Appendix O

Council Correspondence and Meeting Minutes

Preferred Project Application - MP06-0243 (DA07/0589) for 152 freehold residential subdivision (providing for attached and detached dwellings) and future development lot at Lot 9 DP 1039569, Fraser Drive Tweed Heads South

Attachment – Council Officers Comments

ROAD 3 ELBOW DETAIL

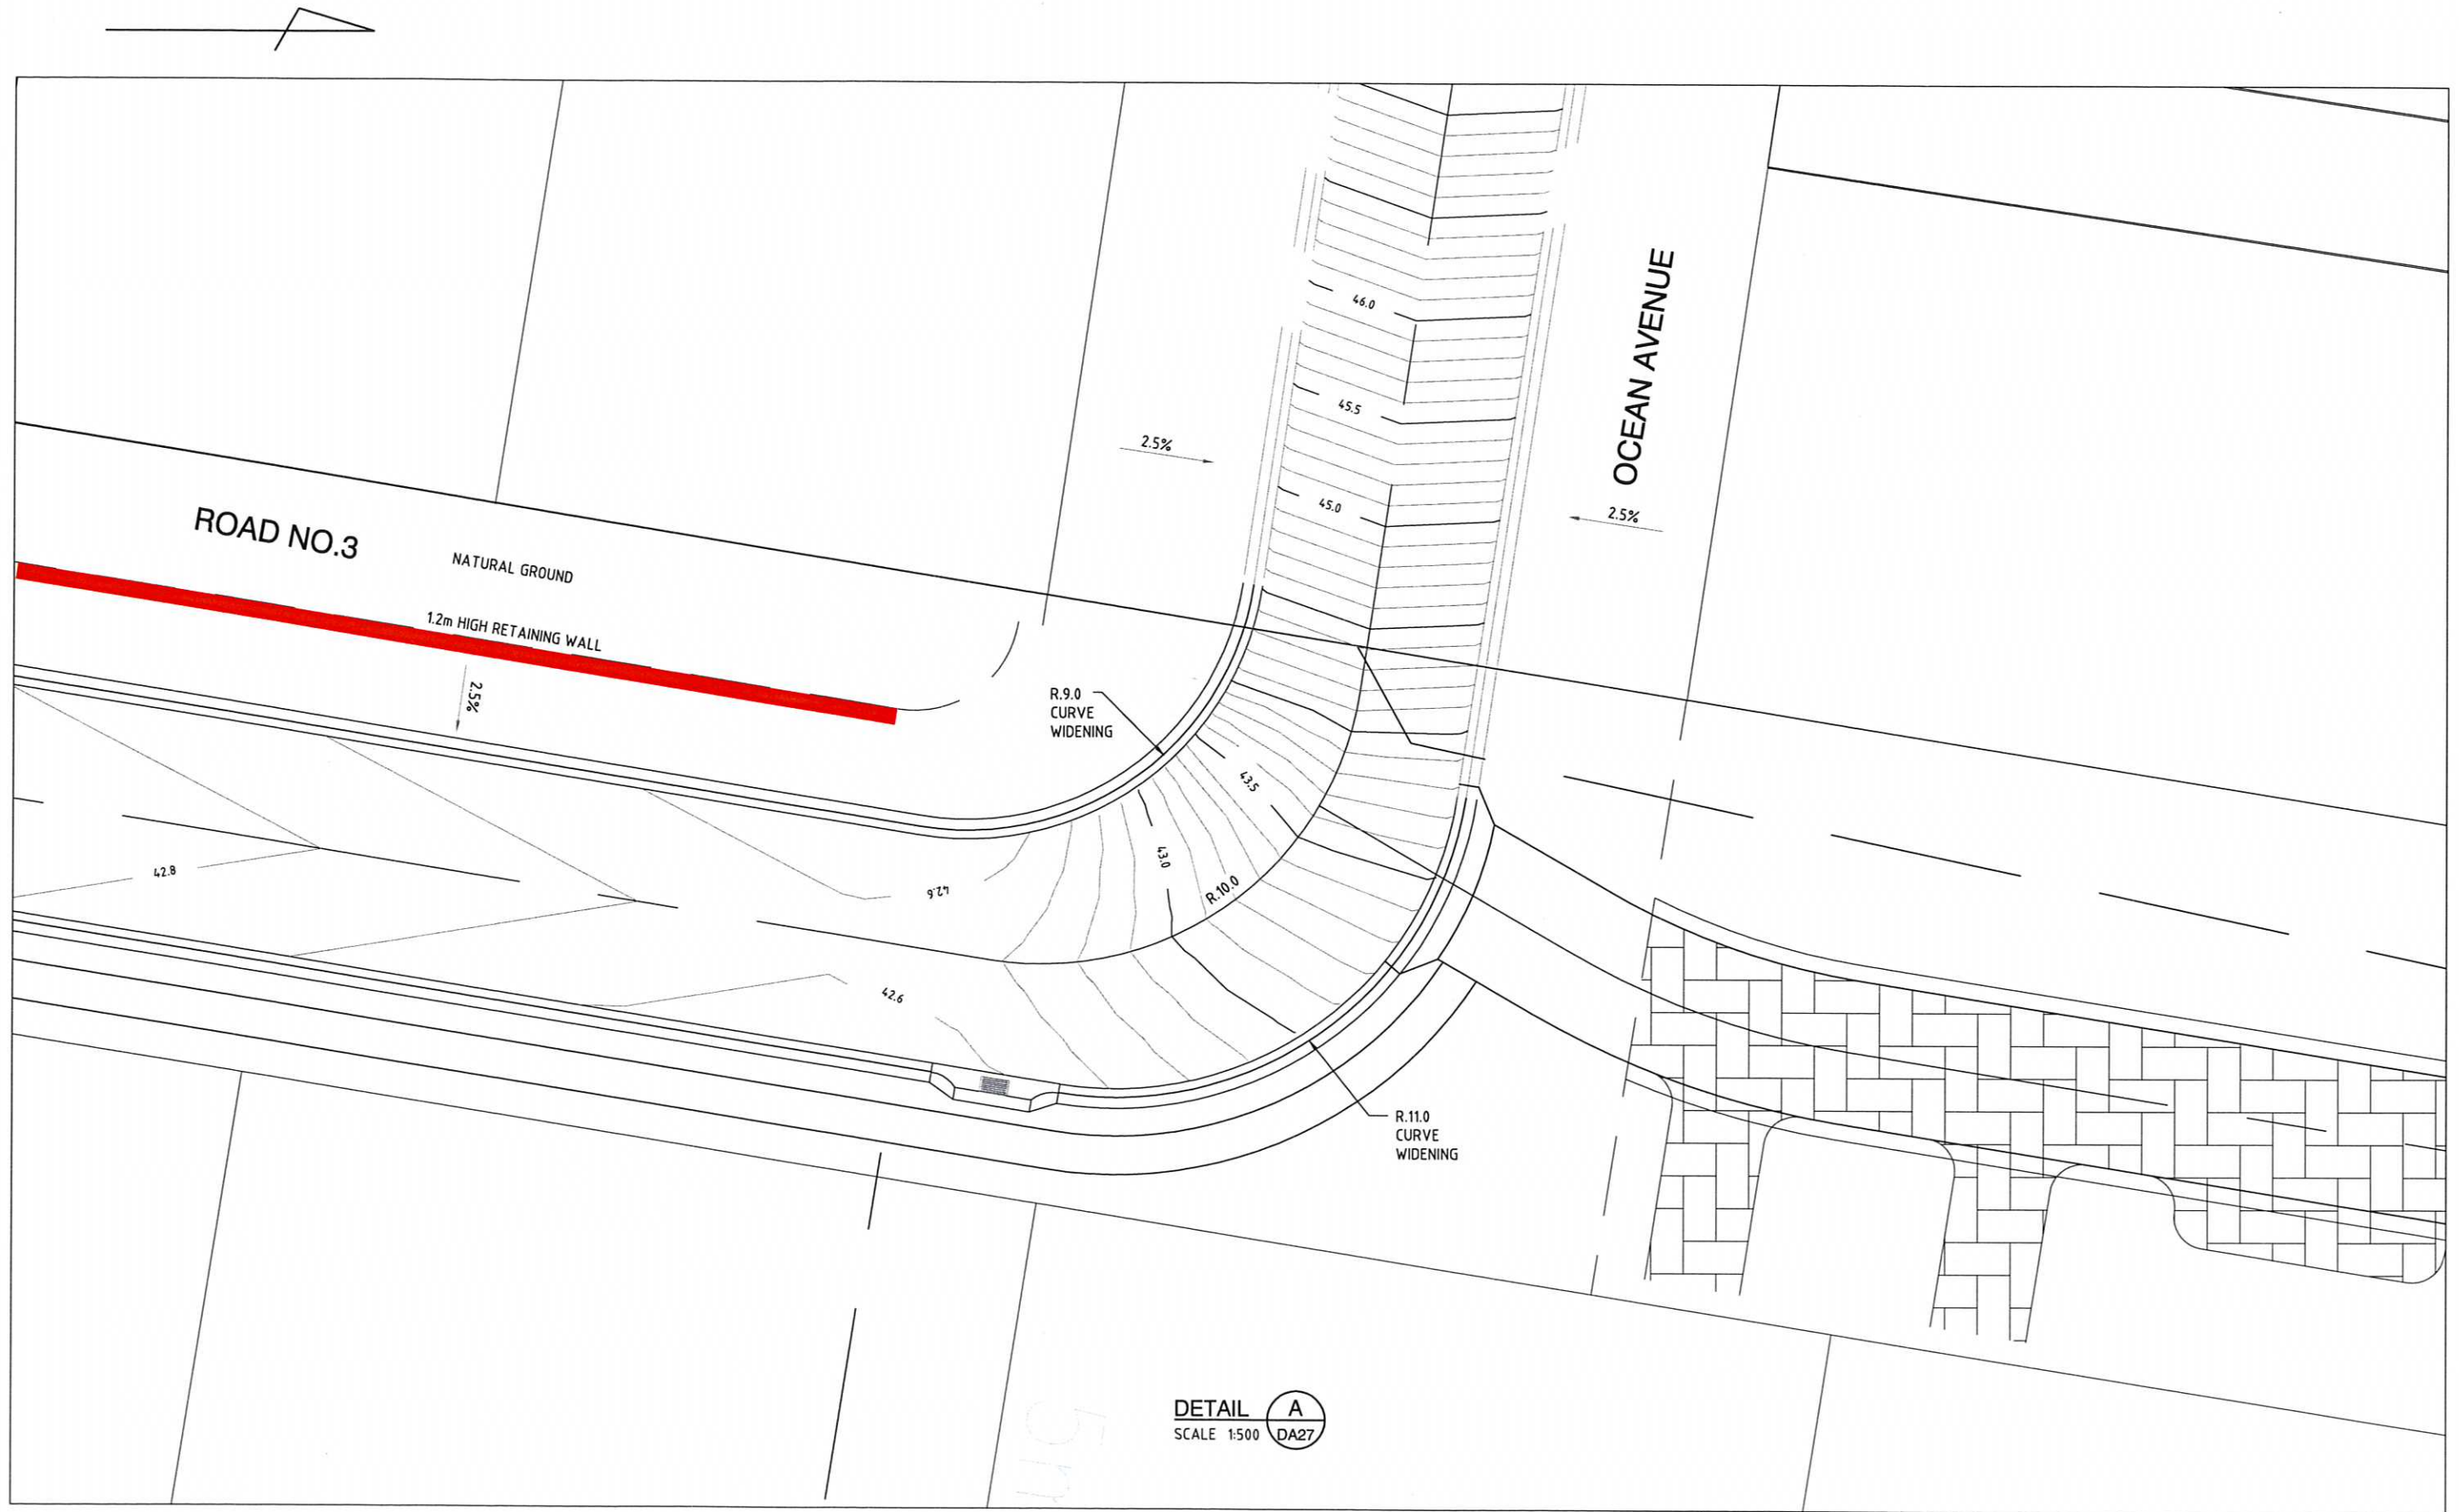
I'm following up on a couple of issues. On the 14 May 2008 we provided Council with further information regarding the Sight Distance for Road 3. We're yet to get any feedback that our response satisfies Council. Could you please advise as we would like to finalise our report.

Please note the drawing for sight distance provided is adequate. In regards to geotechnical testing and recommendations for the compressible clay material in the flat low area of the site, it is considered that a condition of consent prior to the issue of the construction certificate can be addressed in the consent for this information.
